Transport Assessment

Horsley Drive Business Park Stage 2, Horsley Park
State Significant Development Modification

Ref: 1223r02
16/06/2020

Table 1: SSDA 7664 Fairfield Council RFI Response

Figure 15: Cowpasture Road / Trivet Street / HDBP Stage 2 Access

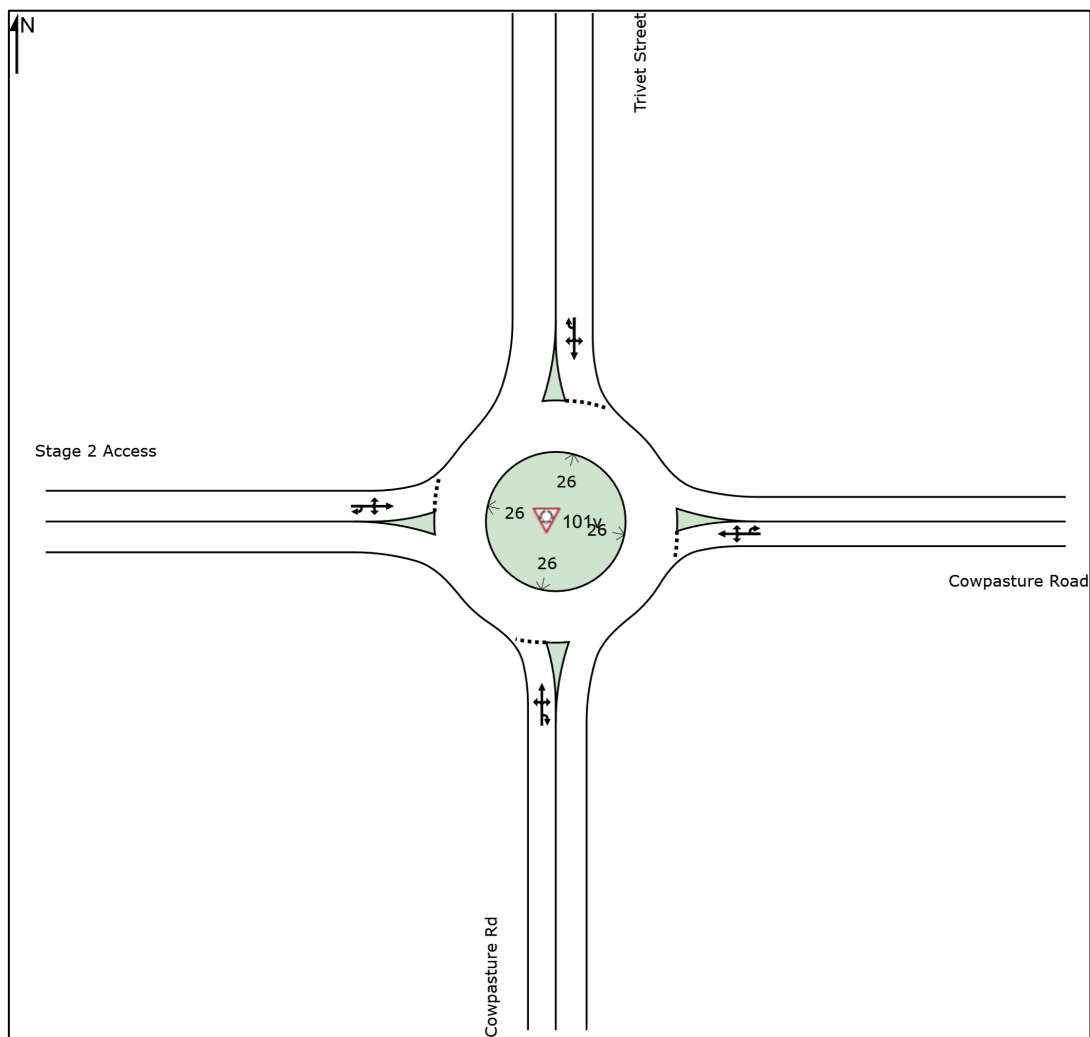
Intersection of Cowpasture Road and Trivet Street	Road safety audit shall be undertaken by an accredited Road Safety Auditor (a qualified person) to identify whether there are issues/risks associated with the installation of a roundabout at the intersection of Cowpasture Road and Trivet Street. A copy of the road safety audit report shall be submitted to Council for assessment.	This will be addressed as a Condition of Consent.
	The design of the road roundabout shall comply with the Austroads Guide to Road Design Part 4B: Roundabouts. Swept path analysis shall be provided to Council to demonstrate that the design of the roundabout is adequate to accommodate the largest vehicle manoeuvring at the roundabout intersection. In this instance, the largest vehicle entering and exiting the site would be 26m B-Double vehicle.	Please refer to Civil Engineer response.
	The installation of traffic control devices such as a roundabout, signs and line markings on a public/local road requires community support and approval from the Fairfield Traffic Committee. Should the road safety audit support the installation of a roundabout, the applicant requires	This will be addressed as part of a suitable Condition of Consent.

to obtain approval from Council's Traffic and Transport Branch. The applicant shall provide Council the consultation outcome and the proposed option for assessment.	
	The installation of a roundabout requires changes to the access arrangements to the adjacent properties which will require consent from the affected stakeholders. The affected stakeholders shall be consulted regarding the proposed changes and the outcome of the consultation shall be submitted to Council for assessment.	This will be addressed as part of a suitable Condition of Consent.
Proposed Estate Road	The construction of an Estate Road to service the development shall be referred to Council's Subdivision Branch for review and assessment. The design of the Estate Road shall comply with Council's requirements.	This will be addressed as part of a suitable Condition of Consent.
	The applicant shall submit a swept path diagram showing the largest vehicle can turn into and out of the Estate Road without being impacted by the parked vehicles on the Estate Road.	Please see Appendix B for swept paths into and out of the Estate Road.

- Finally, with the introduction of the Cowpasture Road / Trivet Street / Stage 2 Access Roundabout, the upgrade from the current priority controlled intersection, results in the intersection operating with an improved performance. The assess intersection layout is shown by **Figure 15**.
